# Blofield Parish Council

Minutes of the Blofield Parish Council Planning Meeting held online via Zoom on Monday 22<sup>nd</sup> March 2021 at 7.30pm – 8.15pm.

**Comments on Highways England A47 Blofield to North Burlingham DCO**

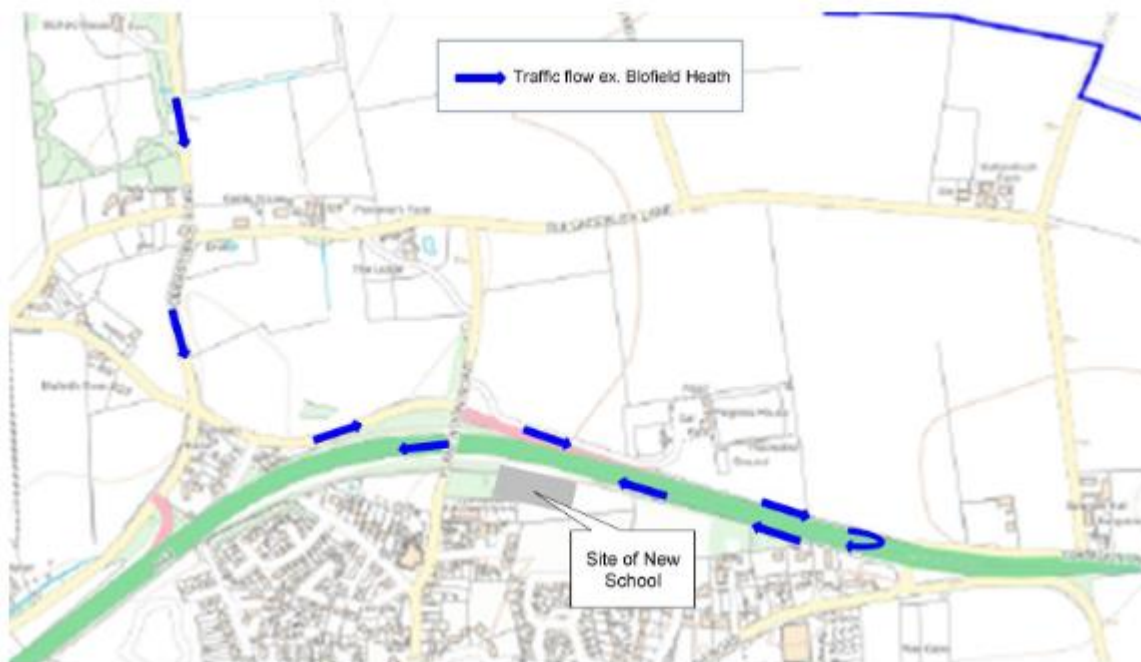
Blofield Parish Council is disappointed that the suggested alternative junction layout has been completely disregarded by Highways England.

This was proposed to Highways England due to the following concerns which have been ignored. Traffic flow from Blofield Heath suggests that a high number of parishioners are exiting Blofield Heath, travelling south towards Blofield, using the slip road to join the A47 East towards Acle and then using the gap in the central reservation to execute a U turn to then travel towards Norwich on the westbound A47, as indicated below.

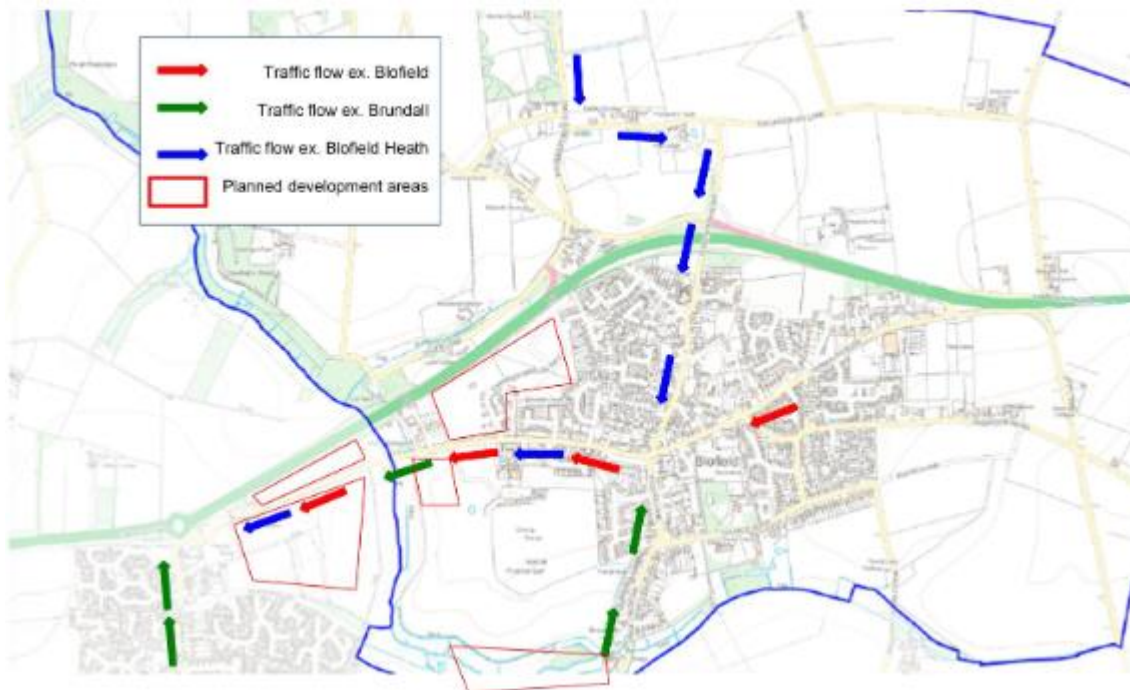
As the proposal for the A47 junction will close off the gap in the central reservation, it is our view that traffic will be forced to enter Blofield and encounter the already congested road network in the vicinity of the current school site, doctors surgery and proposed new school site for onward travel to the A47 Cucumber Lane roundabout for onward travel to Norwich. Proposed development in the parish and beyond our boundary will further compound the traffic flow issues being encountered at the A47 Cucumber Lane roundabout.

Traffic routes shown on the indication above demonstrate that flows from Brundall, Blofield and Blofield Heath concentrate at the A47 Cucumber Lane roundabout which is already causing congestion before the additional development proposals for housing have been built out. Both Highways England and Norfolk County Council refuse to perceive this as a problem either now or in the future and have resisted taking a proactive approach to the problem by planning, instead positioning themselves on a wait and see basis. Local knowledge already sees this as a problem waiting to happen, but no authority will take responsibility for resolving this in advance.

It is with this knowledge why we proposed an alternative layout to the junction that could be achieved with minor alterations to the plans which, in our view, would alleviate the traffic flow issues demonstrated above.
